**From:** "David Henkin" <dhenkin@earthjustice.org>  
**To:** <NRCREP@nrc.gov>  
**Date:** Fri, Feb 9, 2007 4:10 AM  
**Subject:** Docket 030-36974

Here are Earthjustice's comments, with select enclosures, on behalf of Concerned Citizens of Honolulu re: the Draft Environmental Assessment and Finding of No Significant Impact for Proposed Pa'ina Hawaii, LLC Irradiator in Honolulu, Hawaii. A hard copy of our comments, with a complete set of enclosures, has been sent by priority U.S. mail.

Earthjustice submits these comments on behalf of the Concerned Citizens of Honolulu in response to the Nuclear Regulatory Commission's ("NRC's") December 28, 2006 request for comment on the Draft Environmental Assessment and Finding of No Significant Impact for Proposed Pa'ina Hawaii, LLC Irradiator in Honolulu, Hawaii ("DEA"). See 71 Fed. Reg. 78,231 (Dec. 28, 2006). In preparing these comments, Earthjustice was assisted by Drs. George Pararas-Carayannis, Marvin Resnikoff, Mete Sozen, and Christoph Hoffmann, who prepared separate reports critiquing aspects of the DEA and the Draft Topical Report on the Effects of Potential Natural Phenomena and Aviation Accidents at the Proposed Pa'ina Hawaii, LLC

Figure 5. Impact of B767 with steel structure at 100 mph.

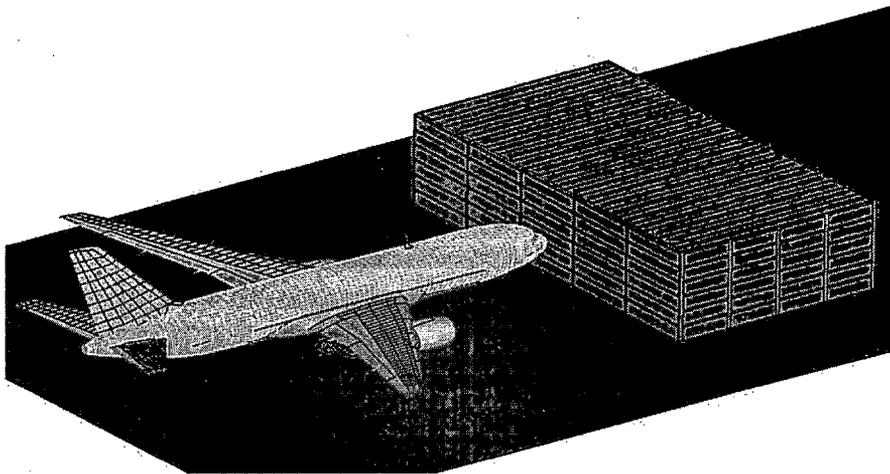
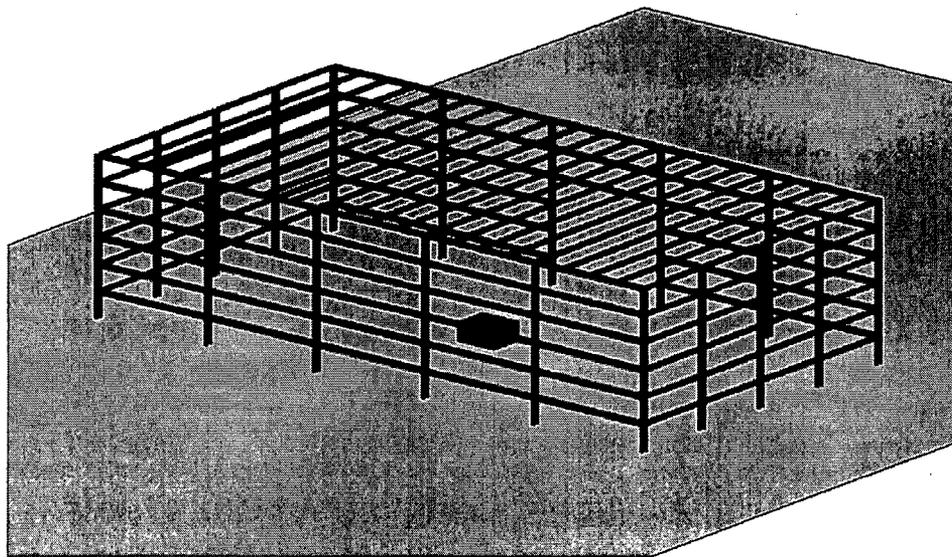
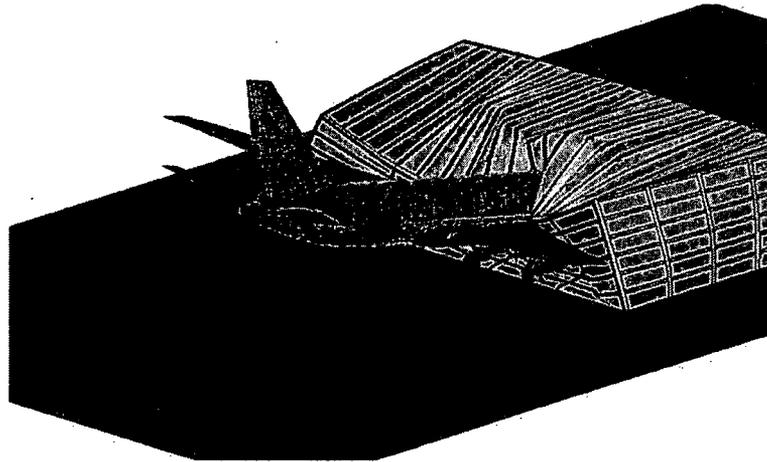
The aircraft was assumed to impact the structure head-on while traveling on the ground at a speed of 100 mph.<sup>2</sup> The “flight path” was assumed to be parallel to the ground and perpendicular to the rear façade of the structure. As depicted in Figure 5, the calculations indicated that the aircraft will crash through the columns and girders of the building. Impact of the structure at any angle would produce similar results.

Because the building was modeled with a toughness that could not be achieved in practice, this simulation results in acute bending of the columns and the girders, visible in Figure 5. Under actual conditions, many of the columns and girders would fracture or be torn off the connections. Debris and fuel would fill the structure, and the fuel would be expected to ignite explosively, causing a massive conflagration. The total damage within the structure would depend on the existing fire load, including the fuel load and the flammable materials within the building. However, the fire is likely to soften all metals, burn all non-metals, and deteriorate the concrete. This could result in a breach of both the source assemblies and the pool, allowing shielding water to escape. The Co-60 sources could also be exposed if extreme temperatures evaporate the pool water or if the force of the impact disperses the source. In addition, all personnel in the building would likely be killed or incapacitated in the event of a crash and conflagration, and Pa'ina Hawaii's proffered emergency procedures would be rendered useless, because no personnel would be there to implement them.

The preceding analysis leads to the conclusion that the effects of a plane crash on an industrial building housing a nuclear irradiator would be devastating. Because the modeled steel structure is more robust and more tenacious than what Pa'ina Hawaii is likely to build, the effects in reality are likely to be greater than the modeled effects. Such an impact could directly destroy the building housing the irradiator and the 3 ½ foot lip of the irradiator pool. Destruction of the pool lip could undermine the integrity of the pool, causing the water shielding the Co-60 sources to drain out. A high-temperature conflagration caused by the impact could destroy the pool by melting the steel. Flying debris could breach the source assembly or pool. In all of these instances, a plane crash would create conditions that could lead to introduction of radioactive Cobalt-60 into the human environment. None of these eventualities was considered by the NRC's EA or Safety Report.

Figure 3. Airport Diagram Honolulu International Airport

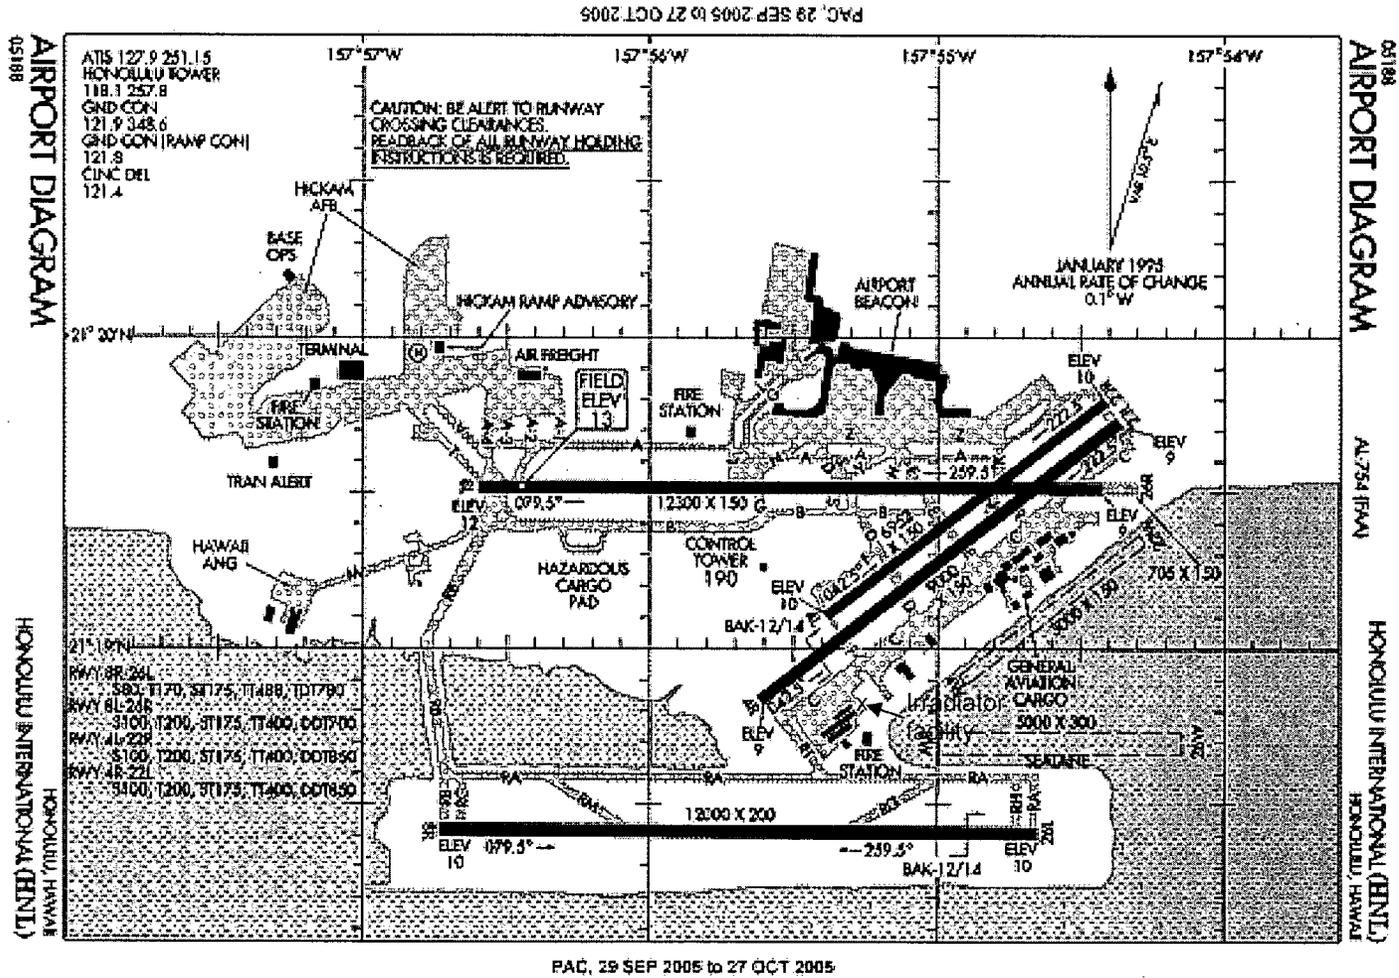
As seen in Fig. 3, the proposed facility is located extremely close to and lies between the runways (4R,22L) and (8R,26L), the reef runway. It is approximately  $\frac{1}{4}$  mile from each runway and a little more than  $\frac{1}{2}$  mile from the major runway (8L,26R). Table 7 lists the distances of the proposed facility from the center of each of the four runways. The conditional probability distributions are probability estimates in one square mile blocks. That is, given a crash, the conditional probabilities provide the probability that the crash takes place in an area of one square mile. As seen in Table 7, the centers of all runways are within one mile of the proposed facility.

**Map 19: Airport to Waikiki**

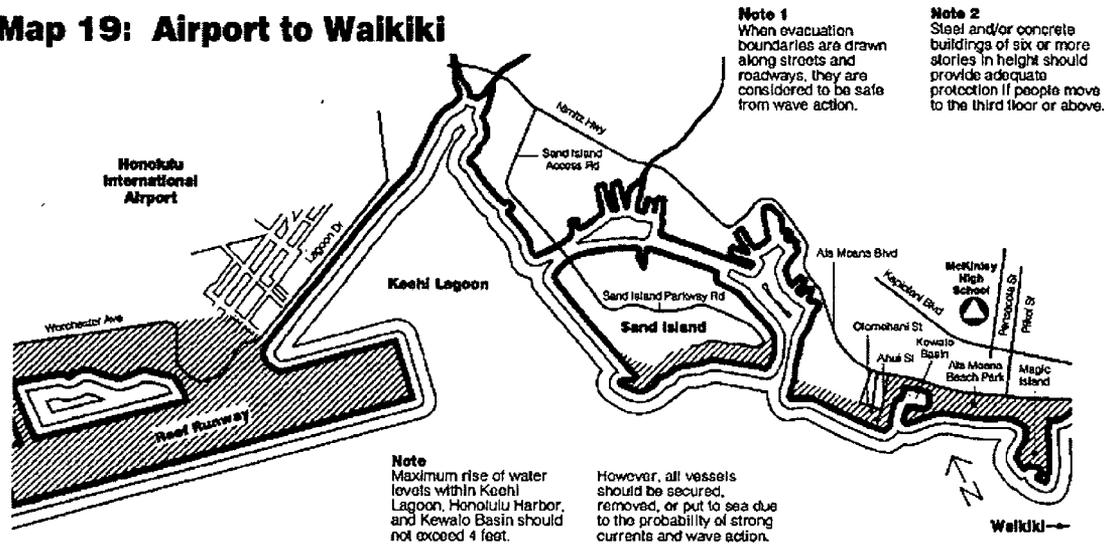
Map 19, provided below, indicates that the tsunami evacuation zone currently extends to the ‘ewa (west) side of the last street on Lagoon Drive. Because Palekona Street is the last street on Lagoon Drive, and the proposed Irradiator site is on the ‘ewa side of Palekona Street, the proposed Irradiator site is within the tsunami zone. Map 18 and 19 also show that the entire reef runway is within the tsunami zone.

**Tsunami Evacuation Limits** – The EA and the CNWRA Report both fail to assess or even mention the fact that the proposed Irradiator site is in a tsunami evacuation zone, based on the Civil Defense maps. Also, the CNWRA Report incorrectly states that the O‘ahu Civil Defense Agency tsunami flood maps (2006) show the Honolulu International Airport above the tsunami evacuation zone. The Civil Defense maps in fact show that the reef runway and some peripheral airport facilities are within the zone of potential tsunami inundation.
